**SERVICE BULLETIN**

**SB670**

- SUBJECT:** Replacement and maintenance of the Continental Motors S-20, S-200, and S-1200 Series Magneto Distributor Block
- PURPOSE:** To advise of availability of improved distributor blocks (see Table 1) and to advise of updated maintenance and inspection procedures.
- COMPLIANCE:** During the next 500-hour magneto maintenance event, or at the next magneto overhaul, whichever occurs first.

Figure 1. Distributor Block Batch-Codes, (S-20, S-200, typical)

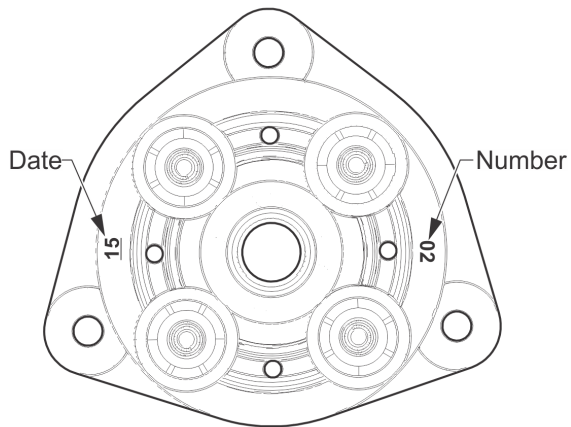
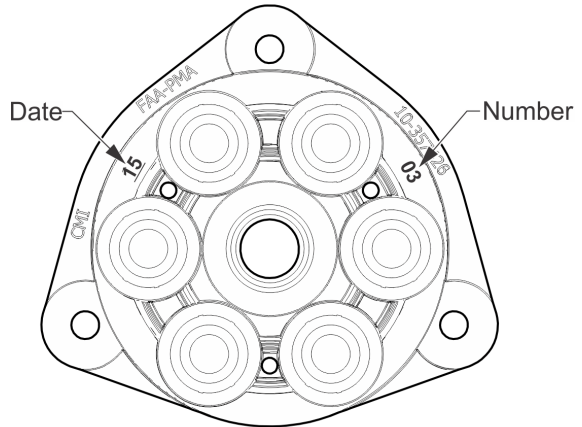
1. Locate the distributor block batch-code as shown in Figure 1 and Figure 2.
2. Replace distributor blocks bearing superseded batch-codes with acceptable batch codes as shown in Table 1. Destroy distributor blocks with superseded batch-codes after removal.

Batch-Code = Date (YR), Dash, Number  
 i.e. Batch-Code = 15-02 (Acceptable)

Batch-Code = Date (YR), Dash, Number  
 i.e. Batch-Code = 15-03 (Acceptable)
